Service Bulletin

Bulletin No. 2009-06

FW40 Lower Unit Change

Lower unit MPF397042

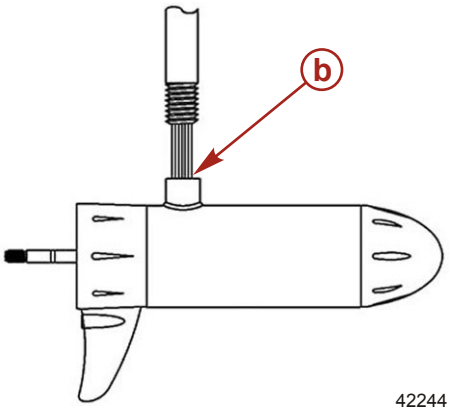
To ensure the weight of the lower unit is distributed evenly across the mount, replace lower unit MPF397042 with lower unit MEF397072.

a - Lower unit MPF397042 – column screws into the lower unit commutator cap.

b - Lower unit MEF397072 – column screws into the lower unit magnet housing.

Lower unit MEF397072

Model	Replacement	Part Number
FW40FB 42" 12V	Lower Unit	MEF397072
